From: Scala, Mary Joy
Sent: Thursday, December 29, 2016 12:18 PM
To: 'Jeff Dreyfus'
Cc: 'jeff@levien3.com'; 'Whitney Glick'
Subject: BAR Action -512-514, 600 West Main Street- November 15, 2016

RE: Certificate of Appropriateness Application
BAR 16-01-04
512-514, 600 West Main Street
Tax Parcel 290007000, 290006000, and 290008000
Heirloom West Main Development LLC, Owner/Heirloom West Main Development LLC, Applicant
New Construction- Landscape Plan

**CITY OF CHARLOTTESVILLE
BOARD OF ARCHITECTURAL REVIEW
STAFF REPORT
December 20, 2016**

New Construction- Landscape Plan

SITE PLAN
SITE PLAN

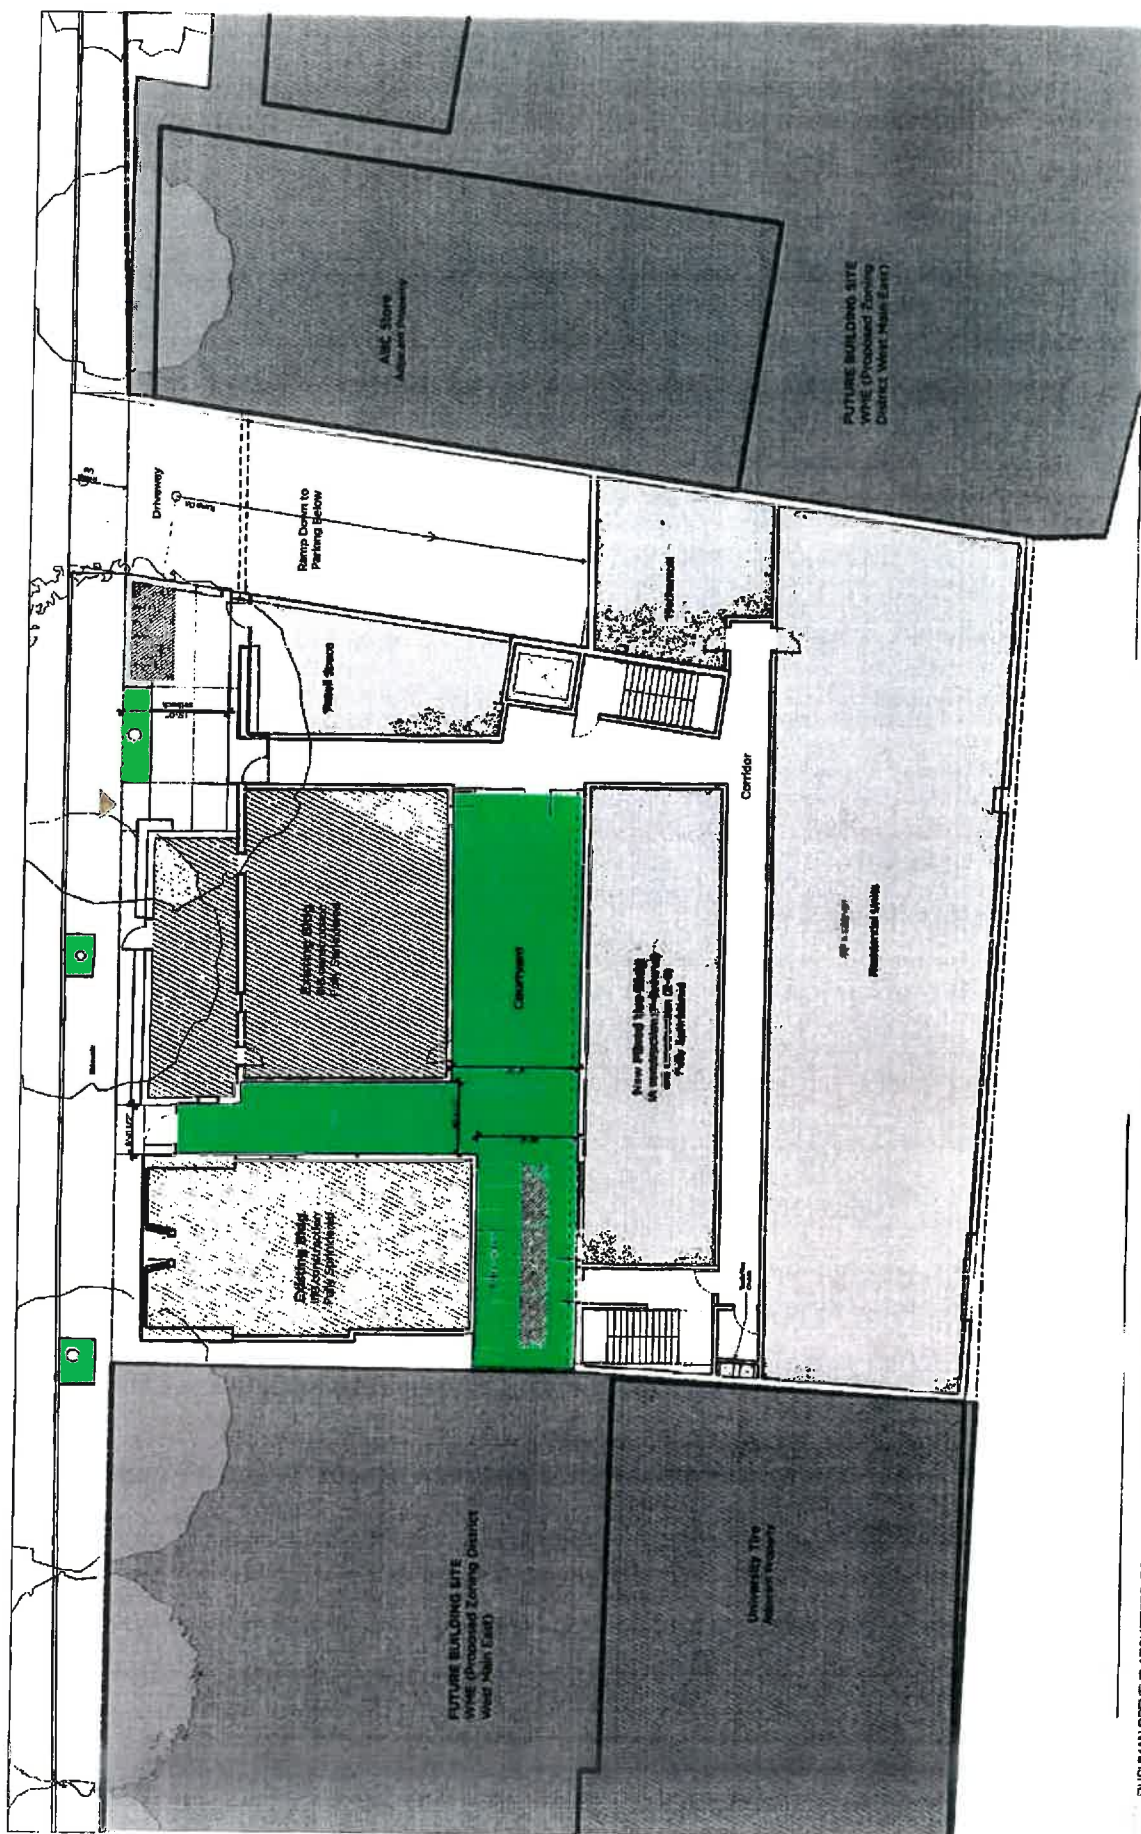
- In general the BAR liked the direction of the courtyard with lots of greenery rather than a purely utilitarian use.
- The green walls are fine but they want assurance that it won't damage the historic structures.
- The zelcova tree could be replaced with something better such as a nice size street tree in that same spot or vicinity.
- Reconsider planters by front door – existing benches do a better job activating the street.
- They really like the idea of dining above the Blue Moon.

SITE PLAN
SITE PLAN

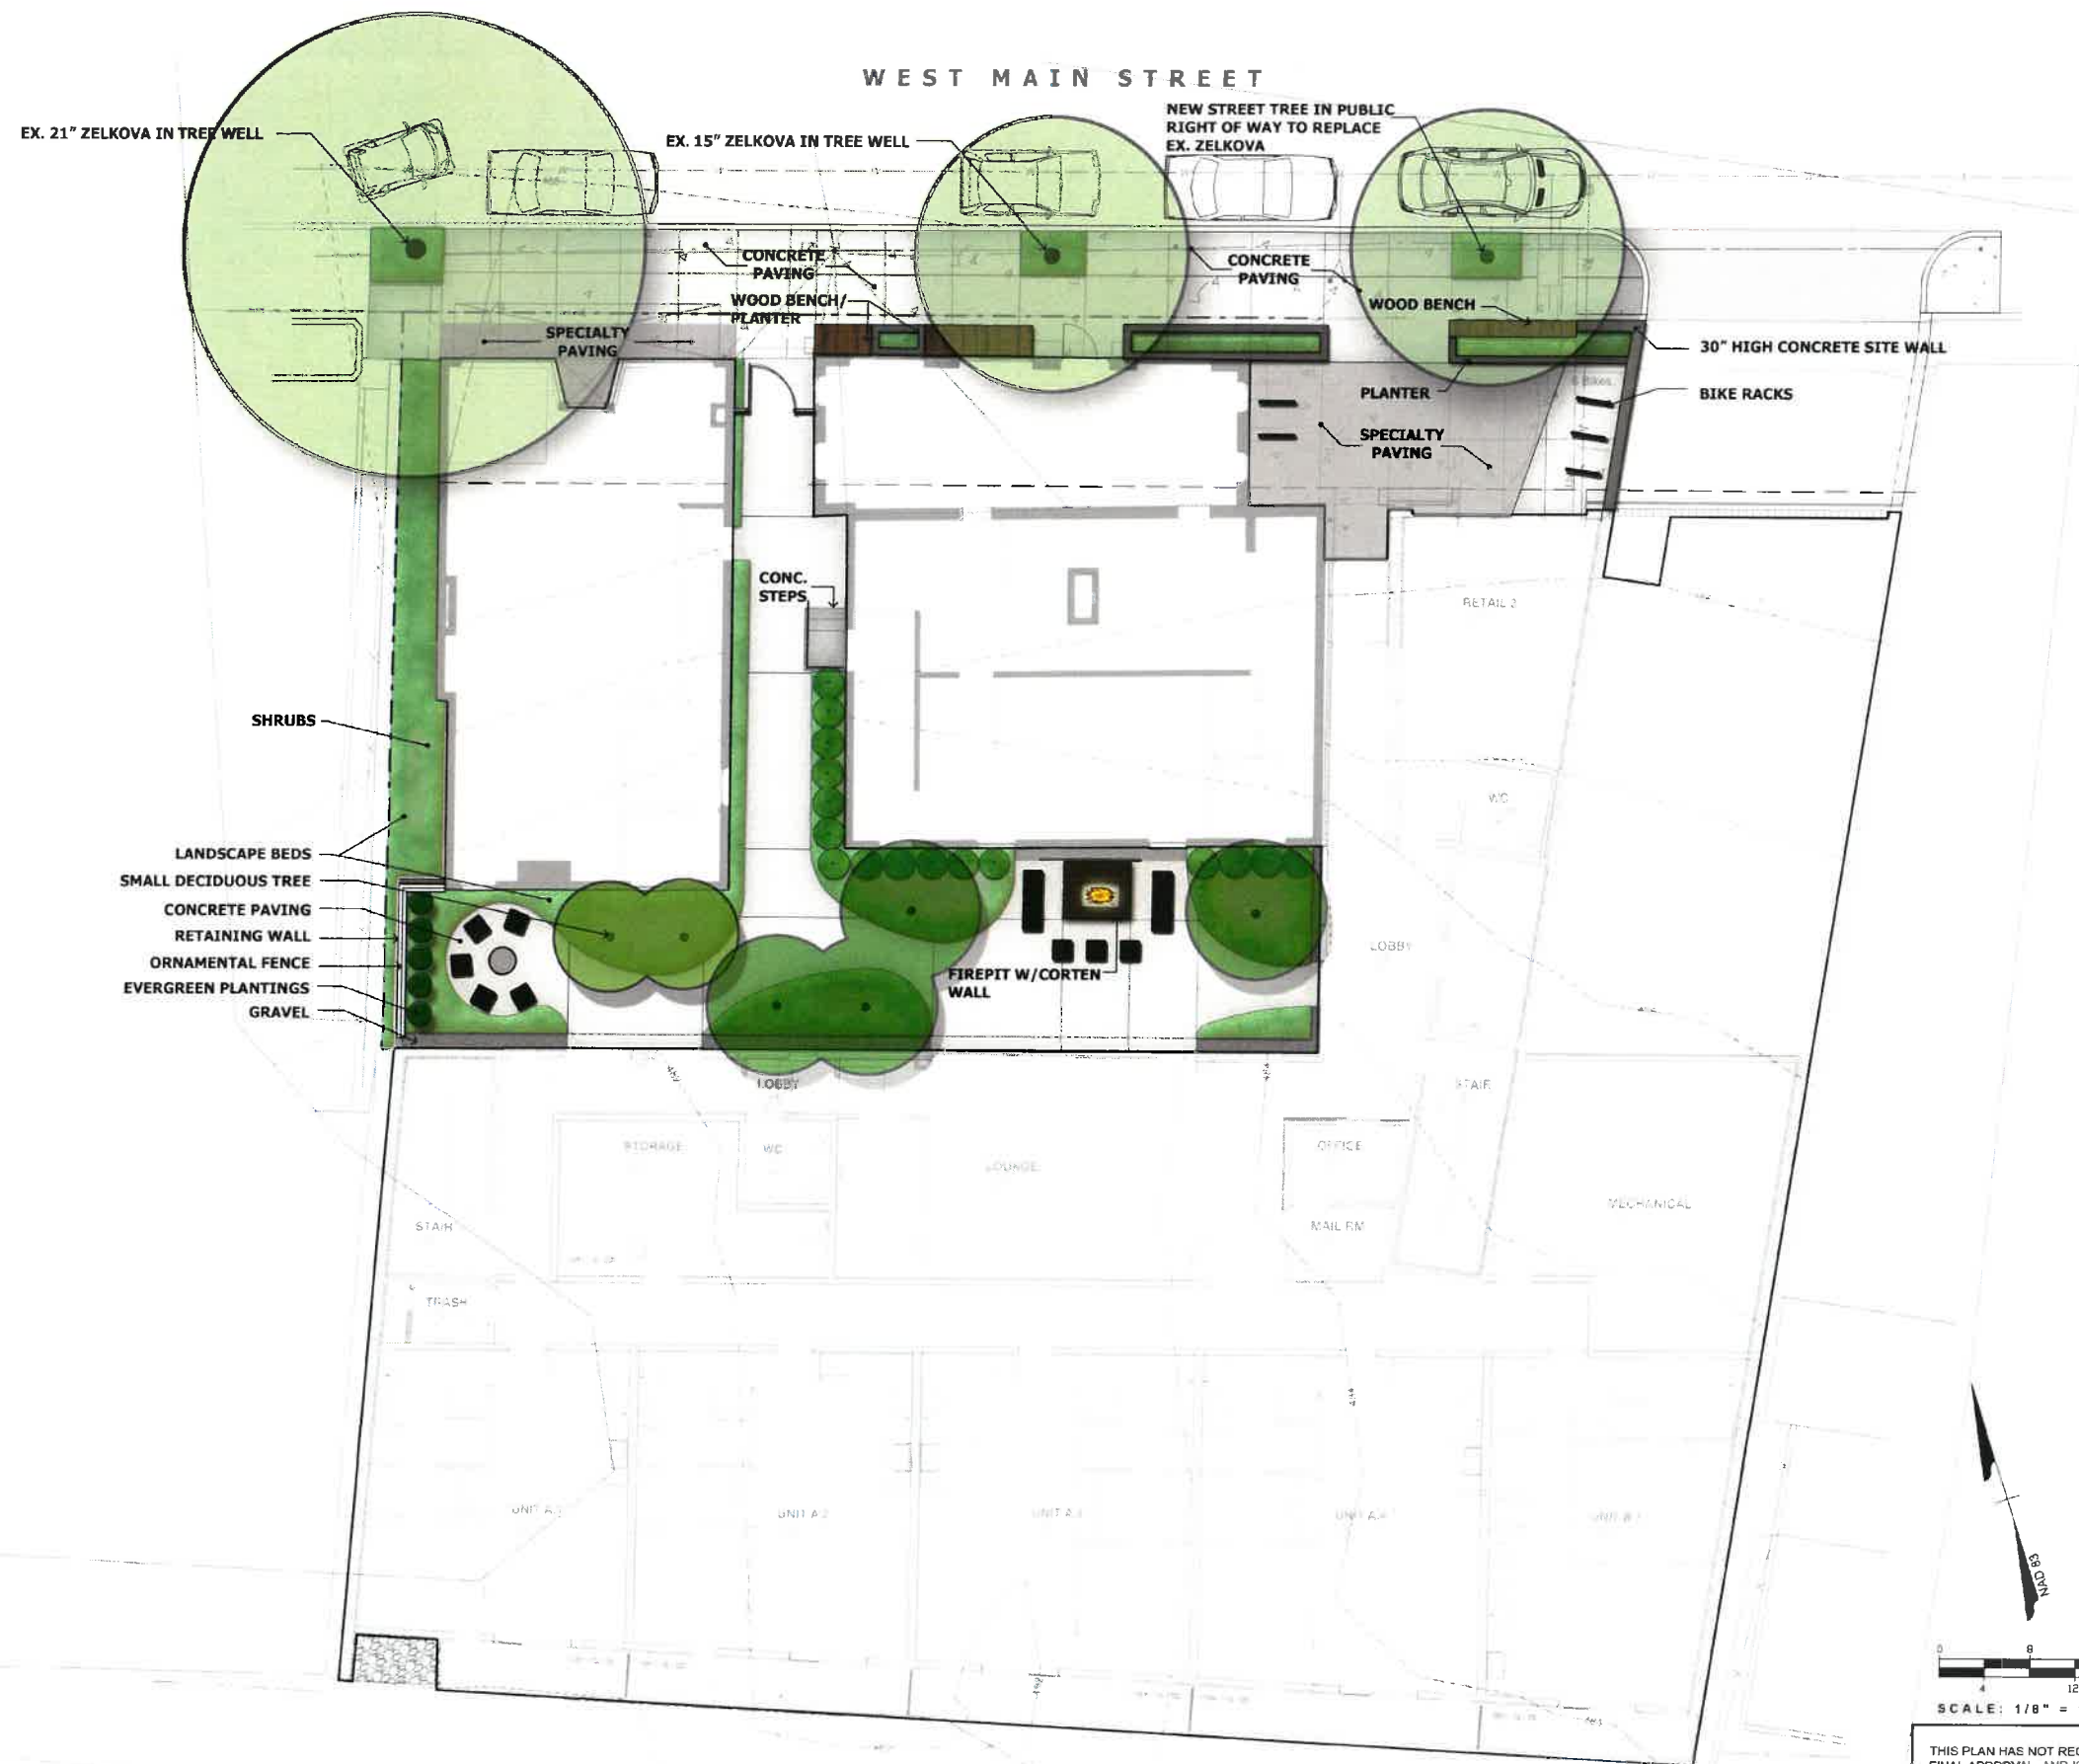
The applicant requested feedback on the streetscape plan. The BAR members like the planters and benches, but there is a pinch point created. Recommended doing it right with a tree grate. Maybe narrower bench or shorter planters, What is W Main consultant's design minimum width for sidewalks? Also suggested looking at changing swing of entry door and making specialty pavement permeable.

- the planters along the sidewalk have been reconsidered and now include built-in seating as well as plantings. We have also eliminated the planters in front of the existing mini-mart building so as not to restrict the sidewalk width where the westernmost street tree and the building are in such close proximity.

- per the BAR's direction, we plan removal of the existing Zelcova tree just east of the Blue Moon Diner and indicate a replacement street tree to be aligned with the 2 remaining trees fronting this property. Relocation of the tree will require approval by the City since we show it relocated into the public right-of-way, and determination of the tree species and planting details will also require coordination with the City.
